000907
 Permit # 000907 City of Portland BUILDING PERMIT APPLICATION Fee 521 Zone
 Please fill out any part which applies to job. Proper plans must accompany form

BUILDING PERMIT REPORT

ADDRESS: 13 Colonia L ST. DATE: 24/July/98
REASON FOR PERMIT: TO CONSTRUCT A 12'x16' DECK.

Typical Platform Deck Design

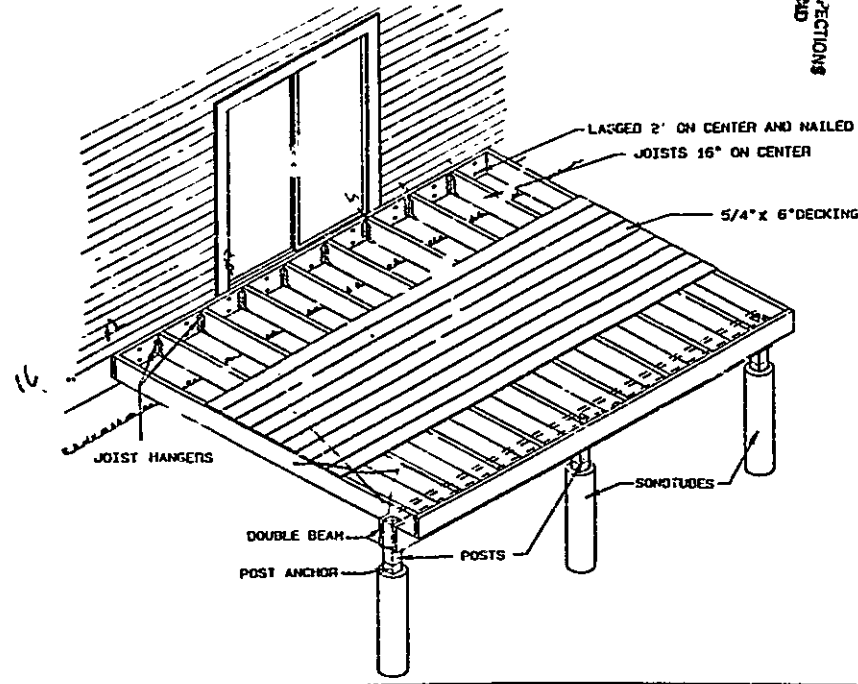
K A guardrail system located near the open side of deck or elevated walking surfaces shall be constructed. Guards in buildings of Use Group R-3 shall be not less than 36 inches in height. Open guards shall have intermediate rails, balusters or other construction such that a sphere with a diameter of 6 inches cannot pass through any opening.
